Access Compliance Report Public Rights-of-Way (Curb Ramps)

Main Street: NEWPORT_AVE Cross Street: 17TH_ST Location: SW

ADA ID: RPRK211007130941 Ramp Type: Type 1 - Perpendicular Diagonal Initial Pass/Fail: Fail Overall Compliance: No Severity Score: 32

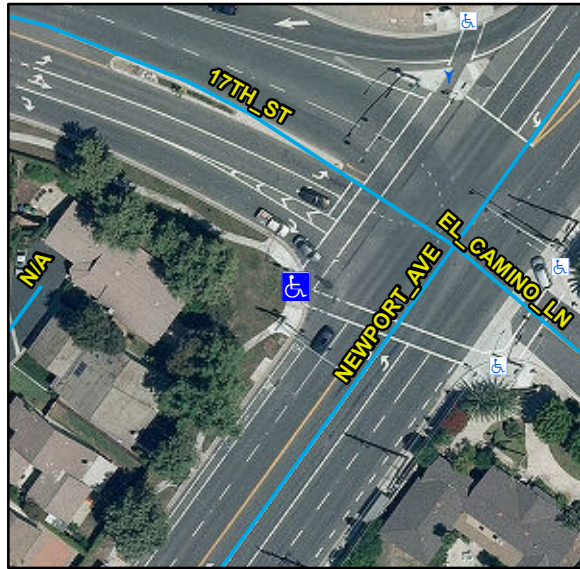
R304.2.2, R304.5.3, STD 1115

Remove & Replace Curb Ramp With Two New Directional Ramps or Equivalent.
